**Byers Gill Solar
EN010139**

8.4.11 Statement of Common Ground with Great Stainton Parish Meeting

Revision 3

RWE Priority Areas

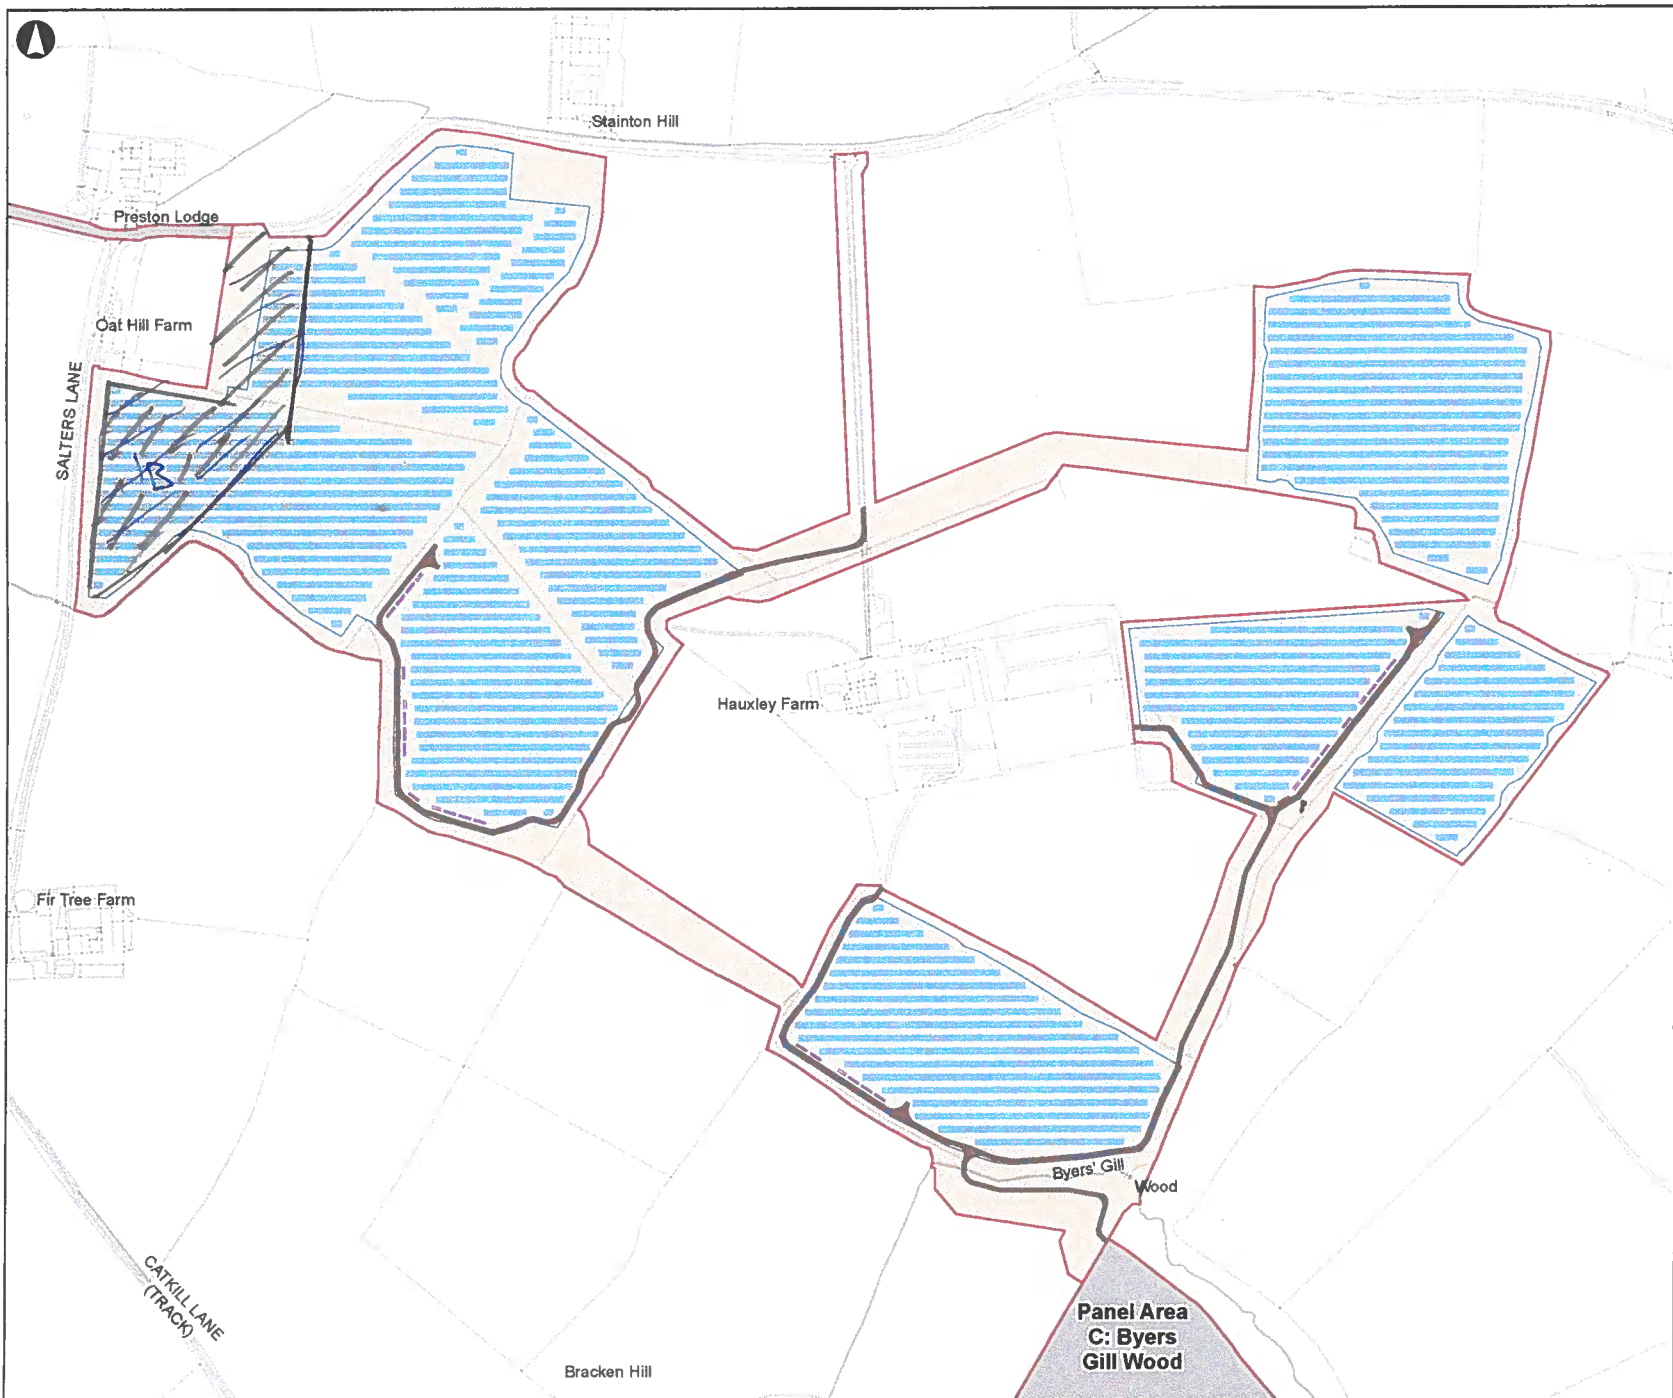
- RWE would like to explore mitigation measures, such as further planting or screening measures including the use of semi-mature planting, or small earthwork bunds.

- RWE have reduced the land area as far as possible as set out in our submissions to the Examination and in the Application. RWE is now committing to continue to look at its design of the scheme through the approval of the final layout at the detailed design stage, controlled by DCO Requirement 3 (if the DCO is granted). RWE wants to agree with the local community where any “priority areas” for any potential removal of panels at that detailed design stage should be, if there is any scope to do so. It may be possible to secure reductions in panel areas at the detailed design stage if new technology is suitable compared to that assumed to date. RWE have provisionally identified priority areas and would welcome feedback on variations of those proposed by RWE or any other specific areas.

- If agreed, RWE would propose to commit to record these areas in the Design Approach Document, which would then inform the approval of the detailed design under DCO Requirement 3 (if consent is granted). The Design Approach Document will also be updated to record RWE’s commitment to consulting with local community groups in respect of these priority areas at that that detailed design stage.

Drawing Title
**Figure 2.6
 General Arrangement Panel Area D**

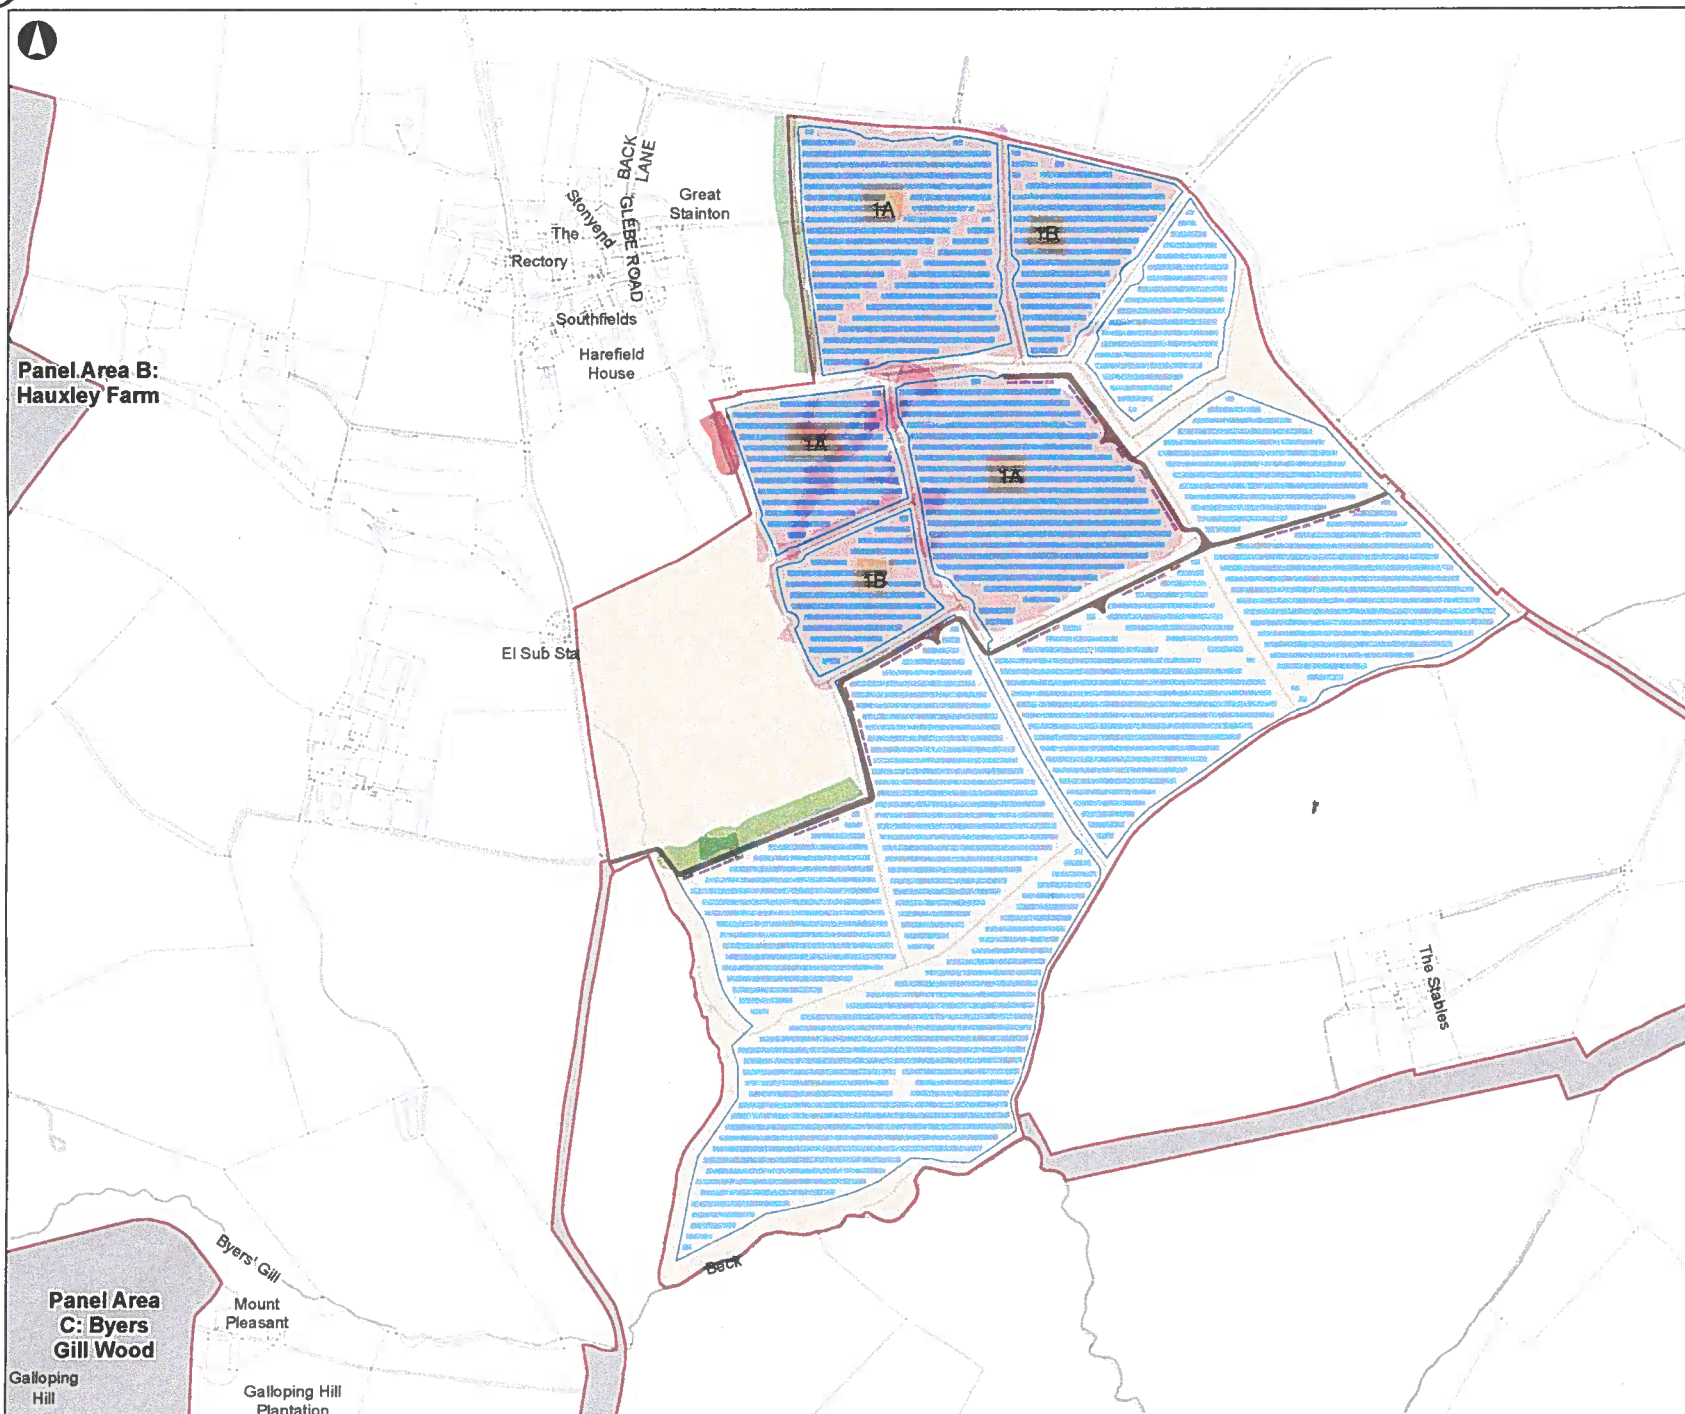
- Legend**
- Order Limits
 - Other areas of Proposed Development
 - Solar PV modules
 - Operational access tracks
 - Battery Energy Storage Systems, inverters, switchgear, and spare containers
 - Fencing
 - Area for mitigation, planting, and enhancement
-
- Bunding and planting
 - Panel Areas to be removed with grading 1A (Highest priority).
 - Semi mature planting to fill gap in existing hedge
- 1A= Areas Highly Visible or extremely close to village**
1B= Areas significantly close or visible

Drawing Title
**Figure 2.8
General Arrangement Panel Area F**

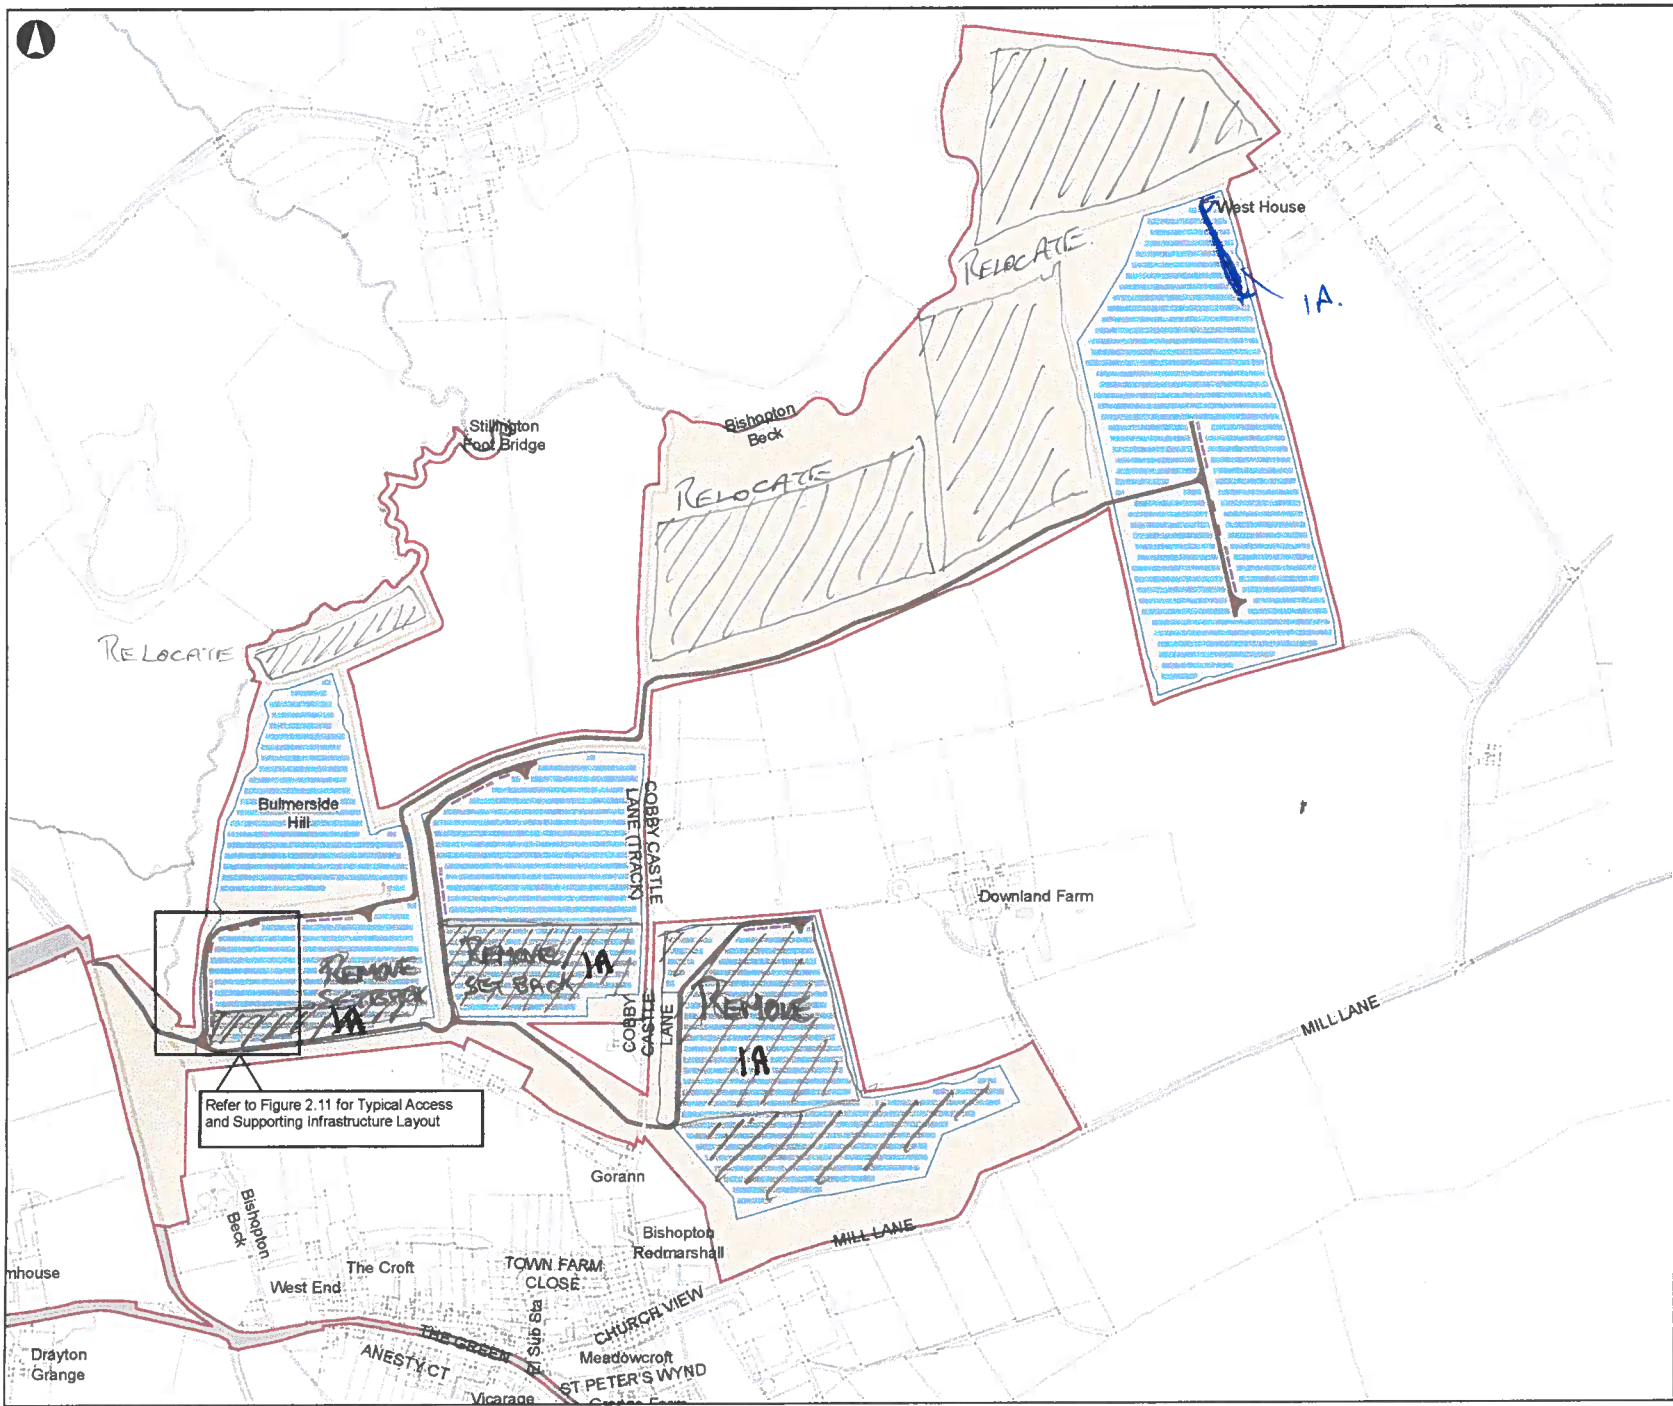
**IA - PANEL AREAS
HIGHLY VISIBLE/MODIF.**
